Access Compliance Report Public Rights-of-Way (Curb Ramps)

Main Street: SWEETWATER Cross Street: ANTONIO_PKWY Location: S

ADA ID: RPRK211019115526 Ramp Type: Type 4 - Parallel Initial Pass/Fail: Fail Overall Compliance: No Severity Score: 30

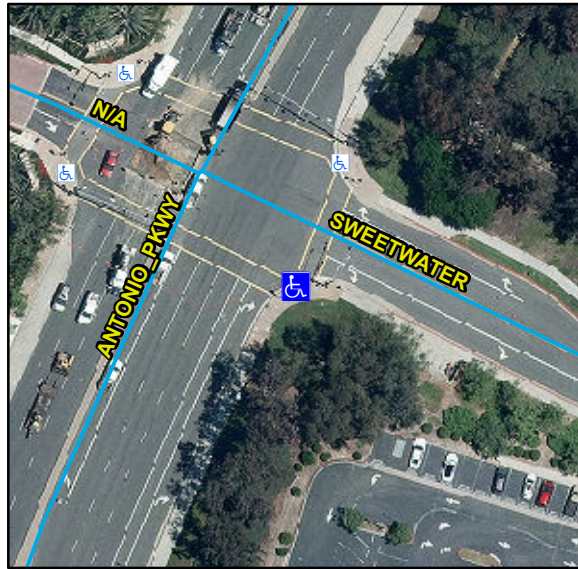
Compliance	Description	Data	Compliance	Description	Data
N/A	Ramp Length LT (in)	100	N/A	Ramp Length RT (in)	86
Yes	Ramp Width LT (in)	74	Yes	Ramp Width RT (in)	72
Yes	Ramp Run Slope LT (%)	8.1	Yes	Ramp Run Slope RT (%)	3.8
No	Ramp Cross Slope LT (%)	9.9	No	Ramp Cross Slope RT (%)	10.2
N/A	Landing Present	N/A	N/A	DWS Provided	N/A
N/A	Landing Length (in)	N/A	N/A	DWS Contrast	N/A
N/A	Landing Width (in)	N/A	N/A	DWS Length (in)	N/A
N/A	Landing Run Slope (%)	N/A	N/A	DWS Full Width	N/A
N/A	Landing Cross Slope (%)	N/A		DWS Offset Type	N/A
N/A	Landing Movement Obstructed?	N/A	N/A	DWS Offset Left (in)	N/A
	Landing Movement Type	N/A	N/A	DWS Offset Right (in)	N/A
N/A	Landing Shared	N/A			
N/A	Clear Space	Yes			
N/A	Clear Space To Crosswalk (in)	48			
N/A	Marked Crosswalk 1	Yes	N/A	Marked Crosswalk 2	Yes
	Crossing 1 Direction	NE		Crossing 2 Direction	NW
	Marked Crosswalk 1 Width (in)	144		Marked Crosswalk 2 Width (in)	144

N/A	Ramp Inside Crosswalk 1	Yes	N/A	Ramp Inside Crosswalk 2	Yes
	Crossing 1 Slope (%)	3.4		Crossing 2 Slope (%)	1.5
	Crossing 1 Cross Slope (%)	3		Crossing 2 Cross Slope (%)	2.2
N/A	Gutter Ponding	N/A	N/A	Curb Slope	2.5
No	Gutter Lip Height (in)	0.25		Road Run Slope (%)	4.6
N/A	Gutter Run Slope (%)	N/A		Road Cross Slope (%)	1.5
N/A	Gutter Cross Slope (%)	N/A	No	Perpendicular Joint Present	No
Yes	Overall Surface Condition	Acceptable			
	Cross Gutter Present?	No		Spandrel Present?	No
	Replace Cross Gutter?	N/A		Replace Spandrel?	N/A

Remove & Replace Curb Ramp With Two New Directional Ramps or Equivalent. Grind Gutter Lip.
